SAMPLE DRAWINGS

SUBMITTAL 1

PROJECT:
SAMPLE DRAWINGS

APPROVAL DATE	-
PLOT DATE	07/11/2024
PROJECT NUMBER	P-5567446
ROOM NAME	GENERAL INFO.
SHEET NUMBER	1CS.01

01 RESTROOMS A402
PLAN VIEW
SCALE: 3/4"=1'-0" ARCH REF.: A13/A606

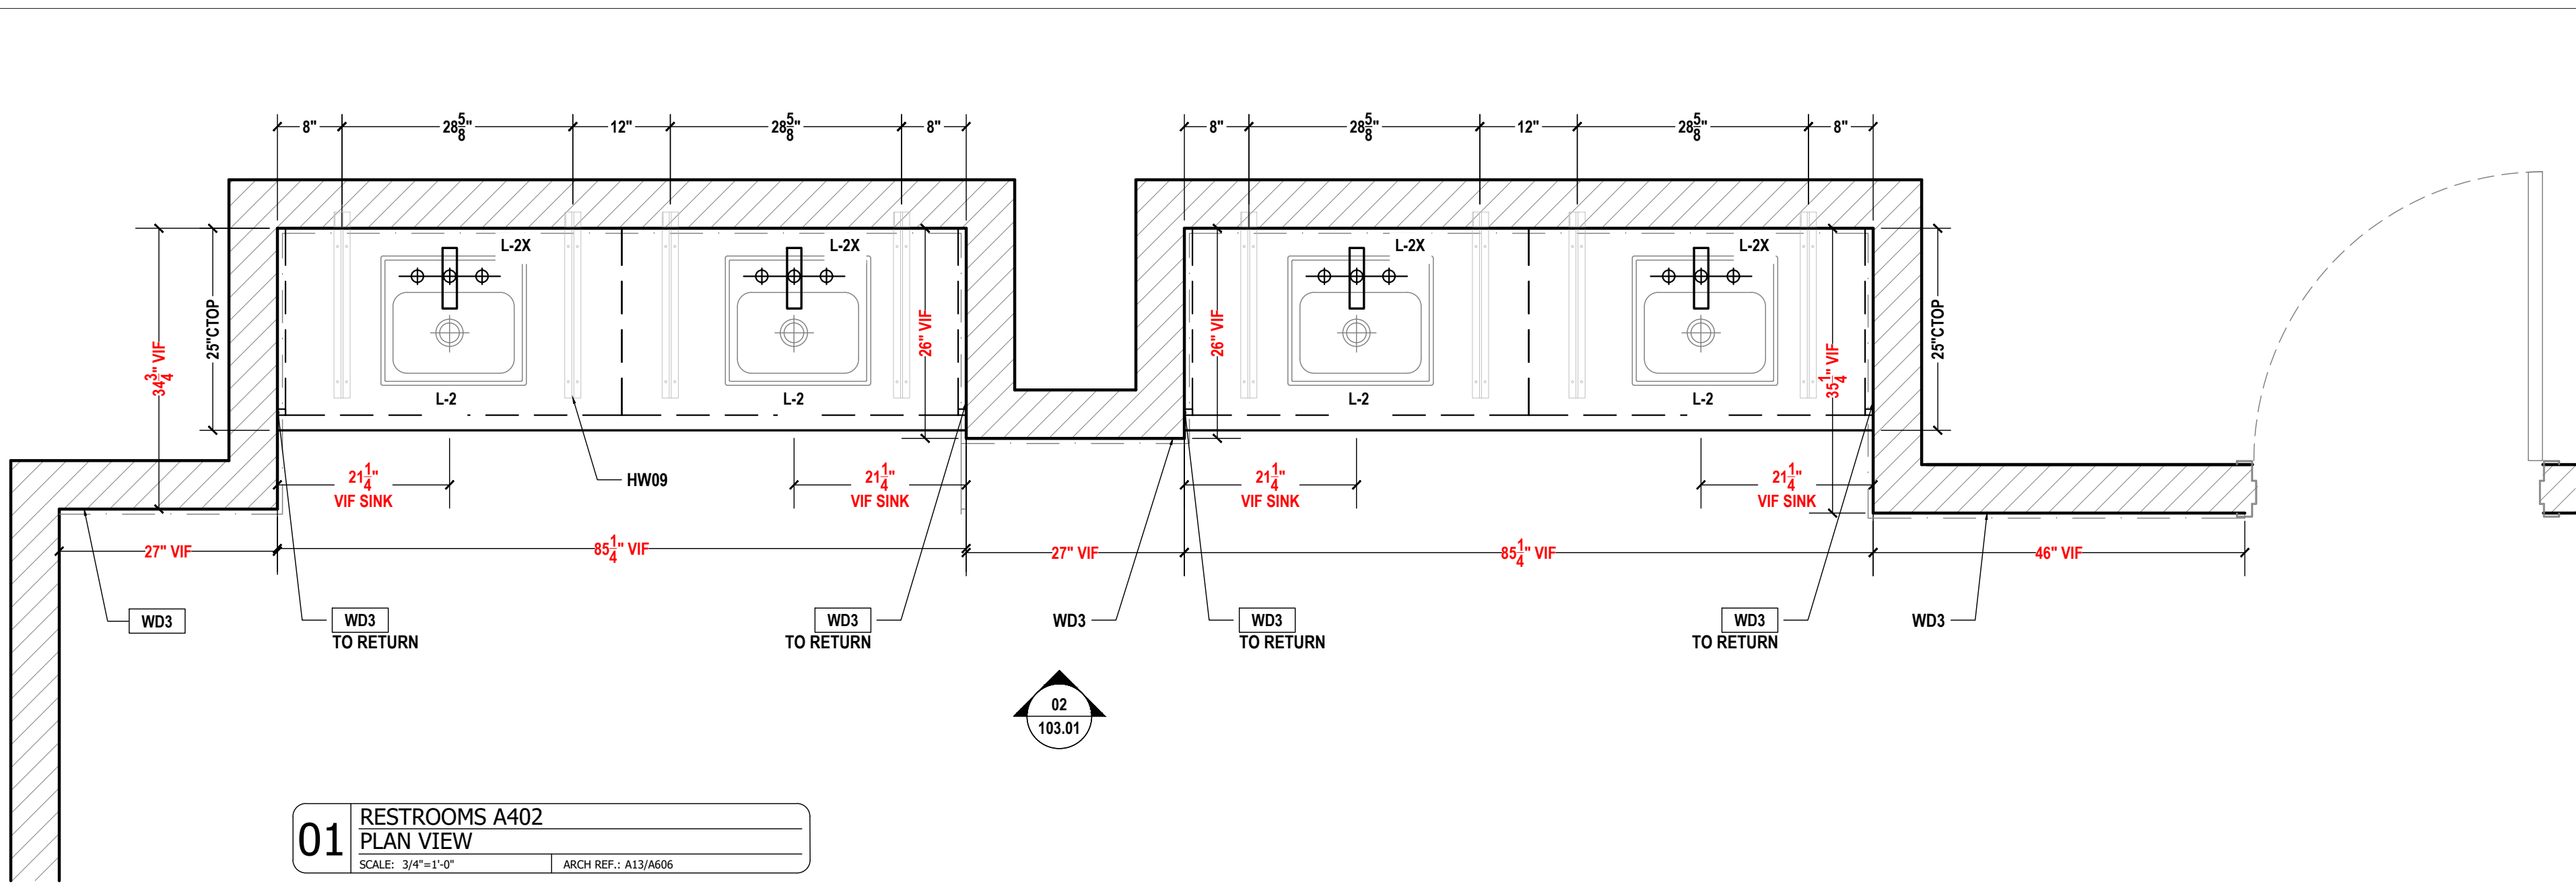
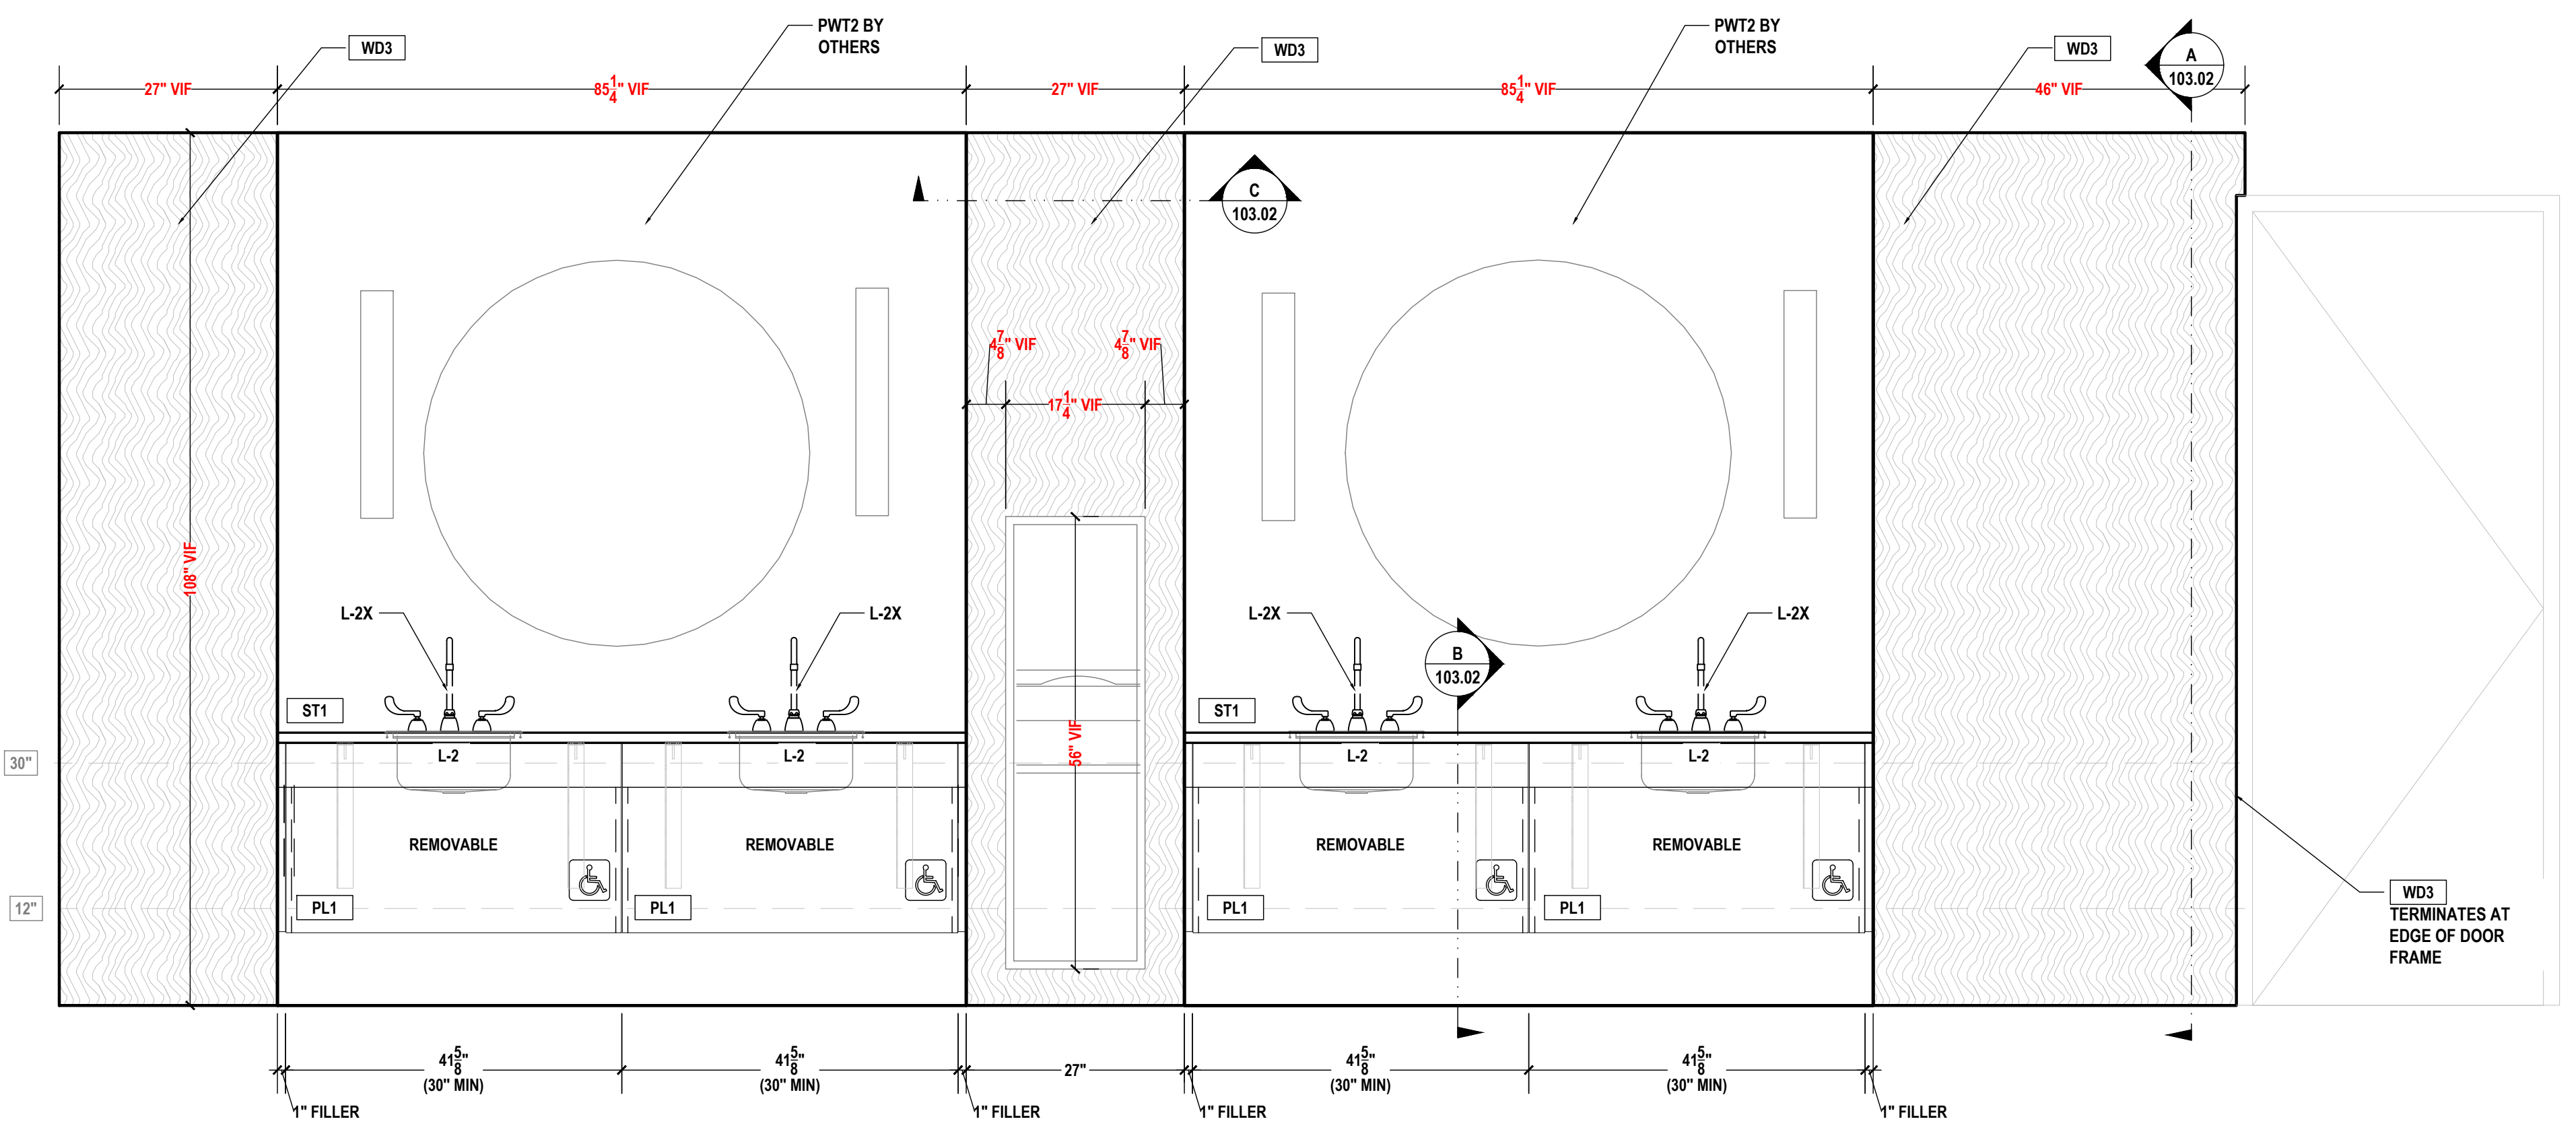
DEVIATION REPORT				
NO.	TMS REF.	ARCH REF.	EXPLANATION	RESPONSES FROM DESING PROFESSIONAL
01	103.01	A10 /12	34"H CABINET HEIGHTS ADJUSTED TO 33-3/4" TO MEET ADA STANDARDS, ALLOWING FOR LEVELING AND SHIMS.	APPROVED BY G.C.
02	1CS.07	N/A	REVEAL OVERLAY, WITH 5/16" REVEALS AT HINGE SIDE OF DOORS, AND HINGES ARE NOT NOTCHED INTO DOORS IN LIEU OF FLUSH OVERLAY.	
03	PAGE#	PAGE#	EXPLANATION	RESPONSES
04	PAGE#	PAGE#	EXPLANATION	RESPONSES
05	PAGE#	PAGE#	EXPLANATION	RESPONSES
06	PAGE#	PAGE#	EXPLANATION	RESPONSES
07	PAGE#	PAGE#	EXPLANATION	RESPONSES
08	PAGE#	PAGE#	EXPLANATION	RESPONSES
09	PAGE#	PAGE#	EXPLANATION	RESPONSES
10	PAGE#	PAGE#	EXPLANATION	RESPONSES

01 BREAK ROOM A204
PLAN VIEW
SCALE: 1/2"=1'-0" ARCH REF.: A1/A608

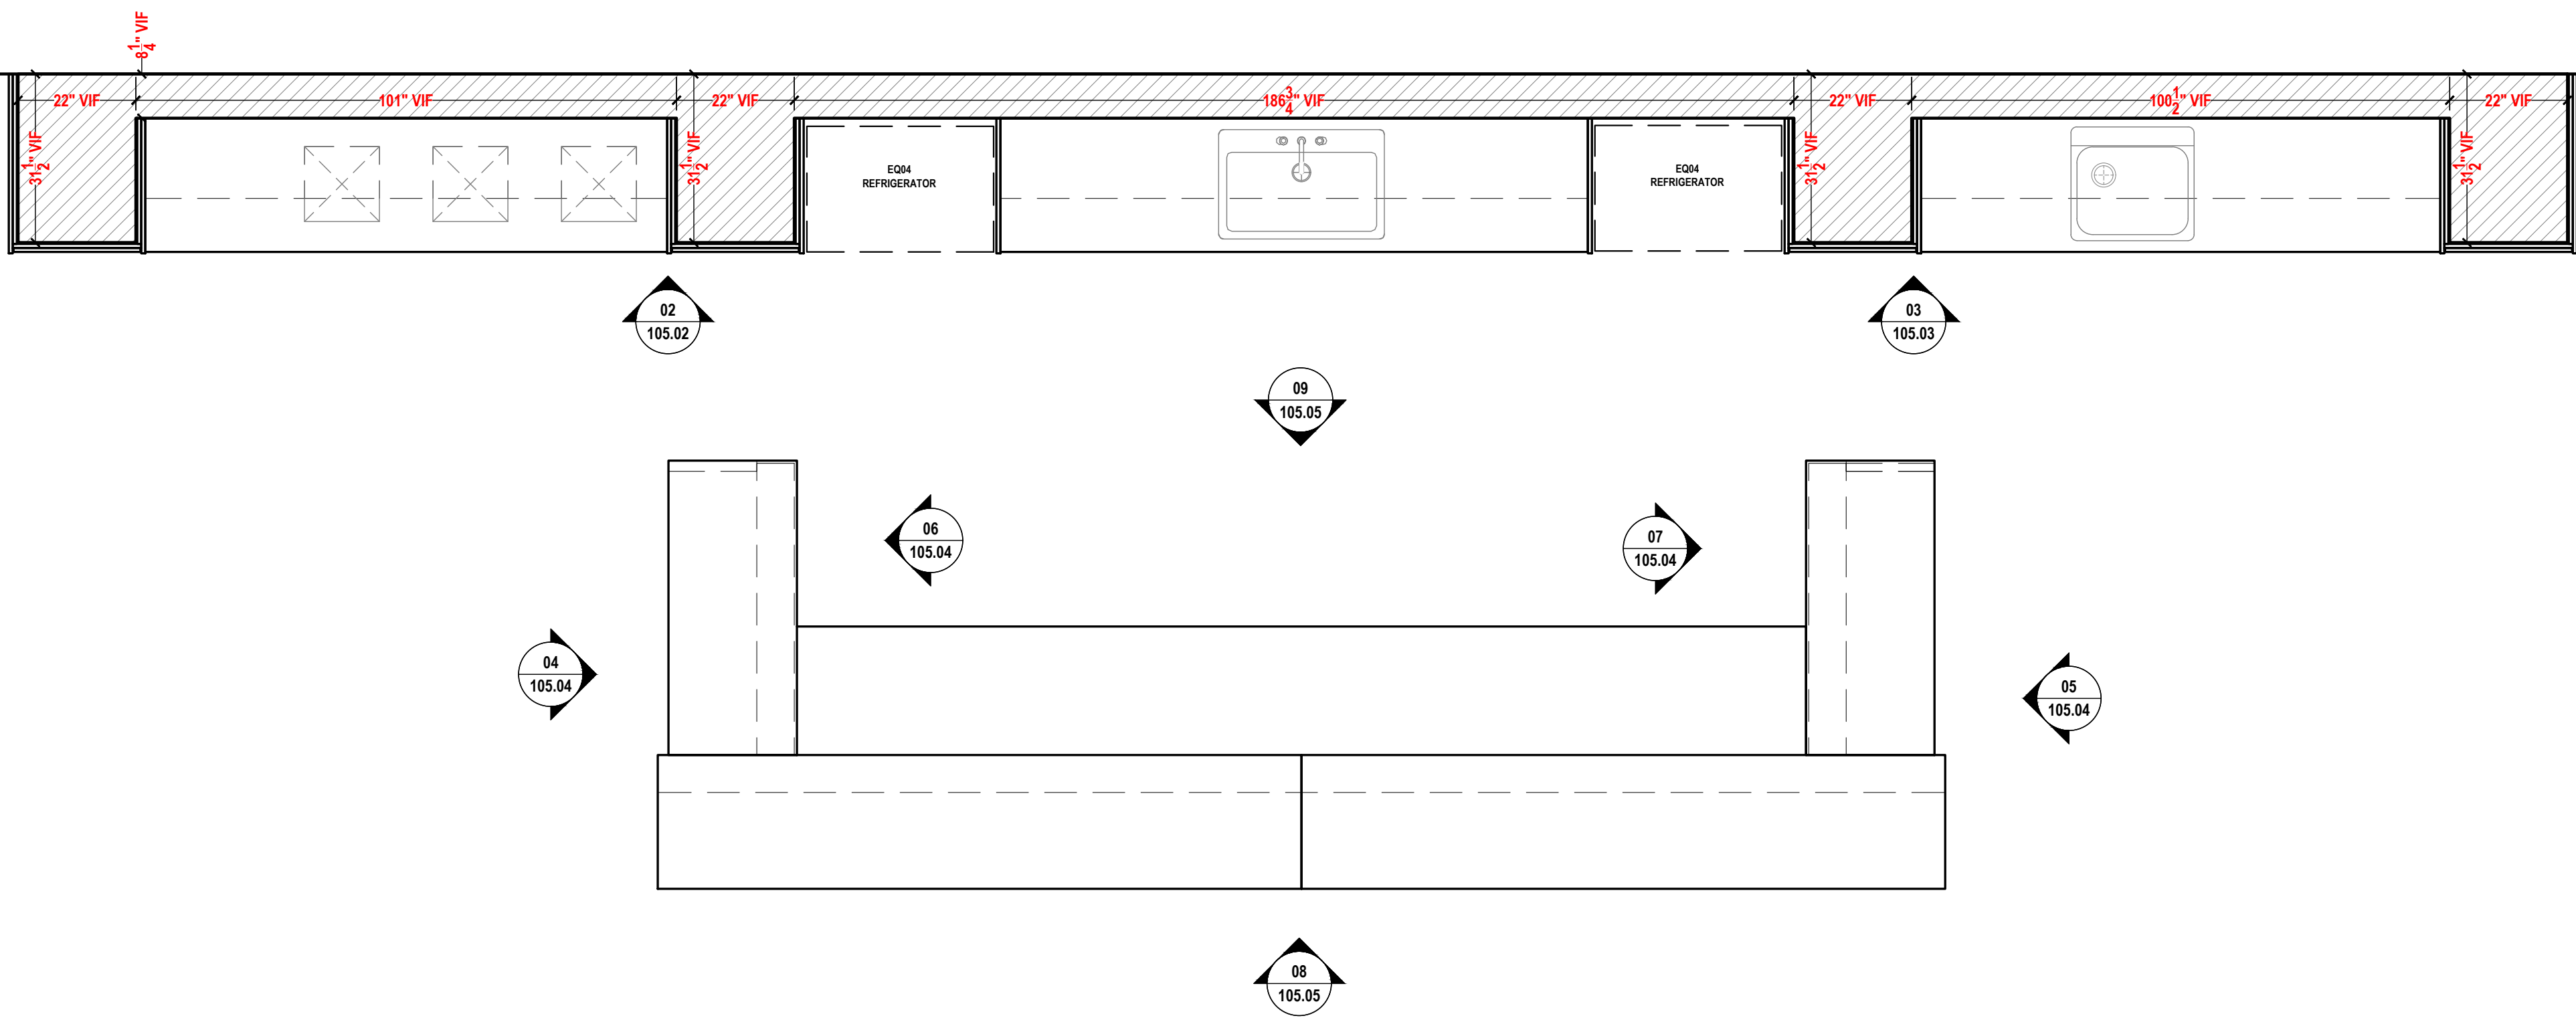
**** NOTE TO ARCH AND G.C. ****
REFERENCE RFI LIST ON SHEET 1CS.02
PLEASE PROVIDE EQUIPMENT SPECIFICATIONS.

RFI'S / CLARIFICATION				
NO.	TMS REF.	ARCH REF.	QUESTION	G.C. / ARCHITECTS COMMENTS
01	03/105.03	A2/A608	PLEASE PROVIDE P-2 AND P-2X SPECIFICATIONS	IN THE APPROVED ADDENDUM G.C. WILL PROVIDE SPECS.
02	02/105.02	A2/A608	PLEASE PROVIDE EQUIPMENT SPECIFICATIONS.	USE THE SAME EQUIPMENT SPECS OF THE WORKING ROOM A108
03	03/102.02	A11/A605	PLEASE PROVIDE WD2 SPECIFICATIONS	WHITE OAK. PROFILE T3T8 RUBIO MONOCOAR
04	09/105.05	A8/A608	PLEASE PROVIDE EQ05, EQ06 AND EQ07 SPECIFICATIONS.	IN THE APPROVED ADDENDUM G.C. WILL PROVIDE SPECS.
05	PAGE#	PAGE#	QUESTION	COMMENT
06	PAGE#	PAGE#	QUESTION	COMMENT
07	PAGE#	PAGE#	QUESTION	COMMENT
08	PAGE#	PAGE#	QUESTION	COMMENT
09	PAGE#	PAGE#	QUESTION	COMMENT
10	PAGE#	PAGE#	QUESTION	COMMENT
